TEDS DESIGN EXCEPTION

FLORA SUBDIVISION 2910 Orchard Avenue - Grand Junction, CO

DESIGN EXCEPTION #DE10-02

RE: Design Exception Request to Delete Sidewalk in the Flora Subdivision

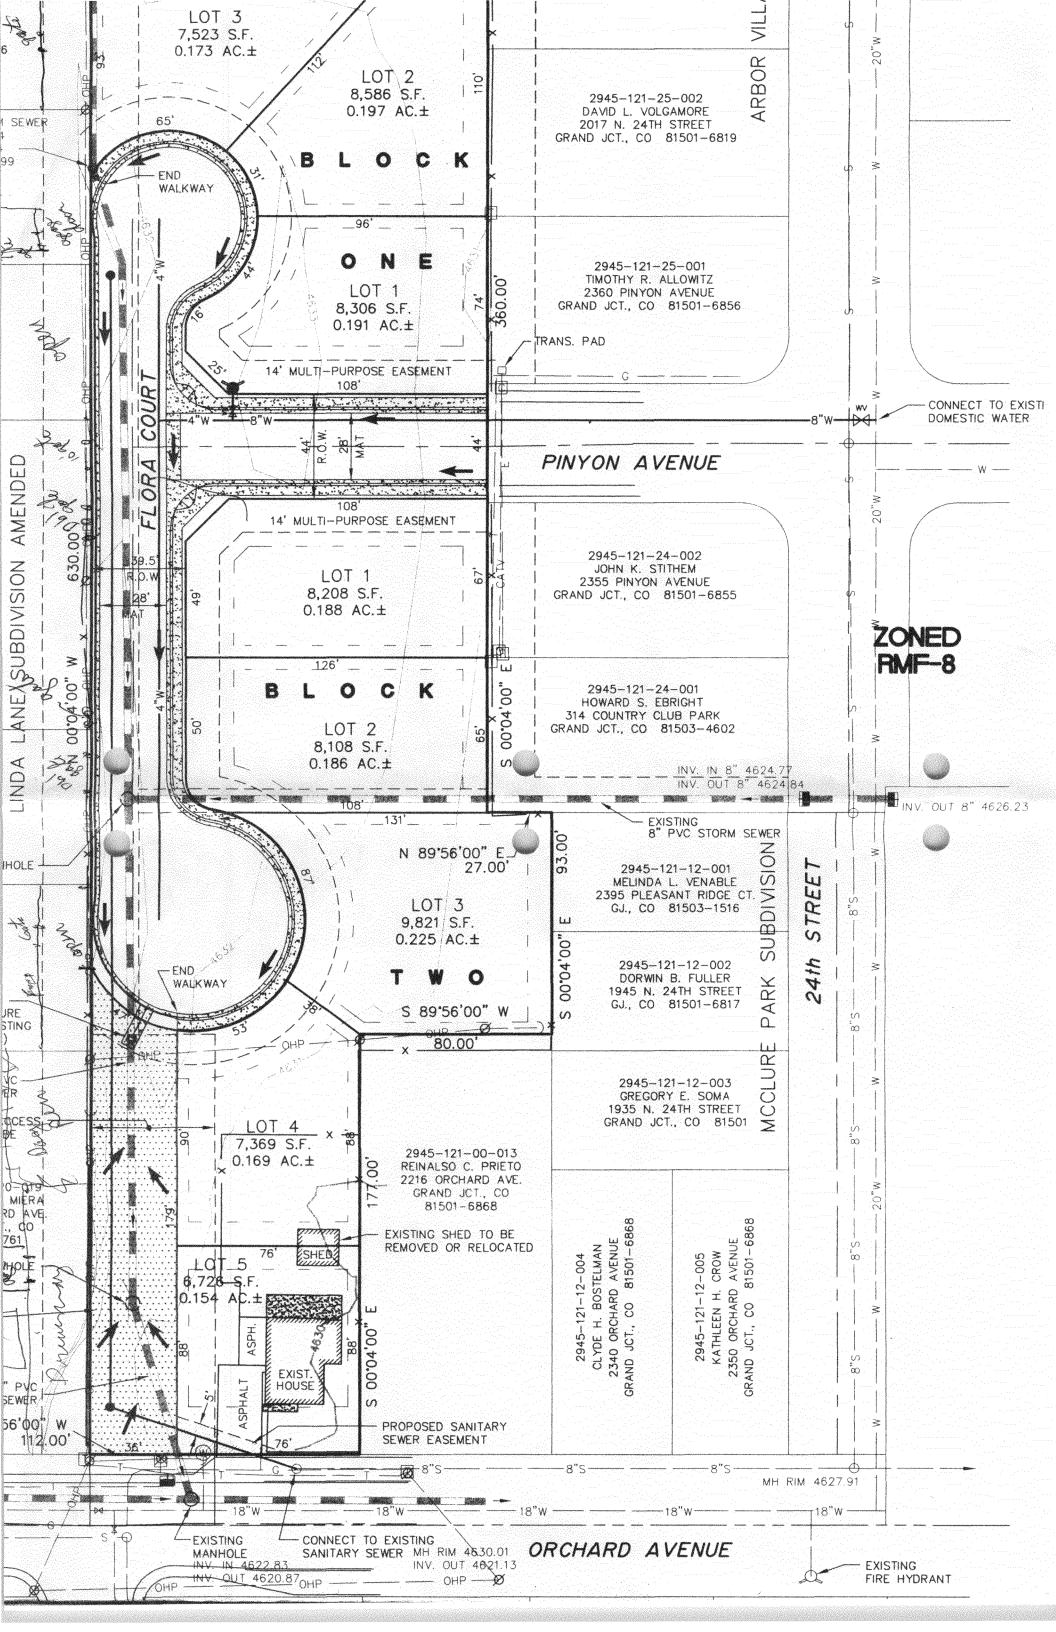
1. Flora Subdivision - The request to eliminate sidewalk on the west side of the street does not appear to consider the backyard gates already present that will access a sidewalk. The design needs to adhere to the street standard of sidewalk on both sides of the street.

The applicant states, "The existing lots to the west would have a walkway in their backyards which they could not access due to existing rear-yard fencing." Field inspection indicates that all of the seven lots that back on to this development have either gates or fence openings along their east property lines.

Properties as far north as 2104 Linda Lane presently use this property for some type of access. Indications are that there is a noticeable amount of foot traffic in this area before any development. These pedestrians will now have to deal with vehicular traffic from the seven new lots. Lack of sidewalk will move these pedestrians into the street.

- 2. Have other alternatives been considered that would meet the standard? Adding this walk would reduce the depth of the east lots by four feet. It appears to me that this reduction in depth will not reduce the ability to build on any of these lots (if that were a concern in evaluating the need for an exception).
- **3.** Has the proposed design been used in other areas? Jody Kliska indicated to me in a telephone conversation that the City has annexed subdivision, which were developed in the County with sidewalk on only one side. In some of these cases the City has had to purchase the right-of-way and build these missing walks.
- **4. Will the exception require CDOT or FHWA coordination?** No.
- 5. Is this a one-time exception or a manual revision? This would be a one-time exception.

I recommend that the sidewalk along the west side of this tee cul-de-sac not be eliminated. In fact it should be extended through the detention tract to provide pedestrian access for the whole neighborhood to Orchard.
